AD469X PCN for DC Spec and AVDD Extension

AD469x Data Sheet Changes

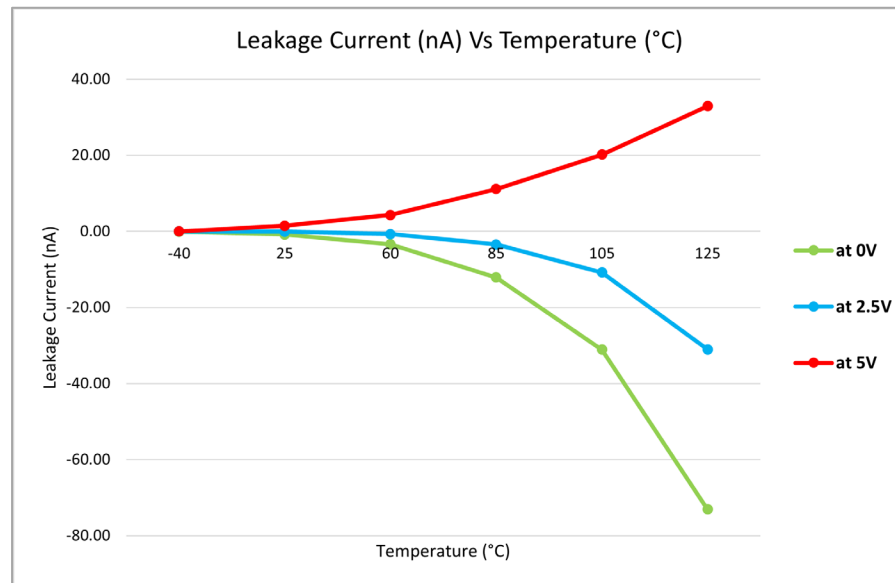
- ▶ TPC Section:
 - AVDD Current vs. AVDD Voltage → extrapolating supply currents from 3.15V to 2.7V minimum

NEW Input Leakage Current TPCs

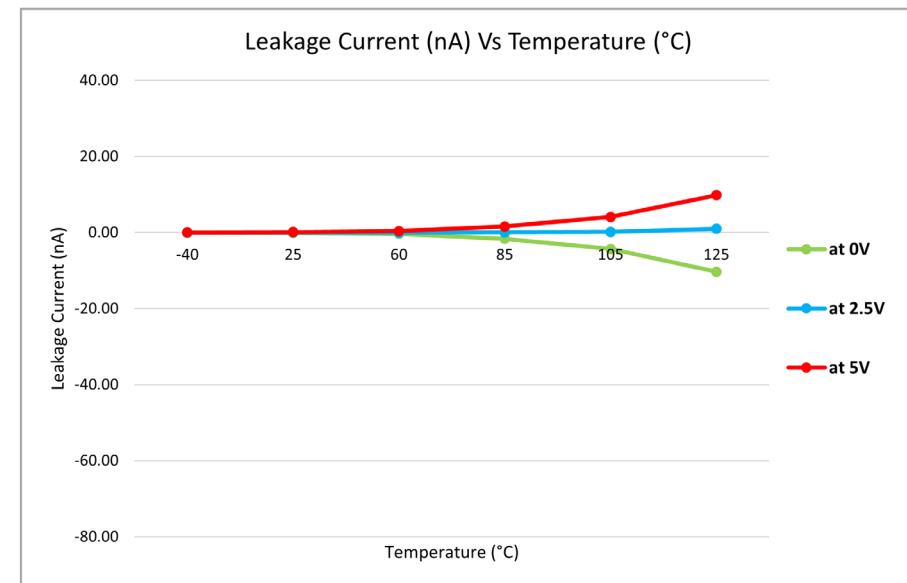
▶ Leakage Current vs. Temperature

- For input voltages = 0 V, 2.5 V, and 5 V

▶ Slotting into Figure 63 for convenience

- Would have been better to group with other Analog Input TPCs but would disrupt the document too much...
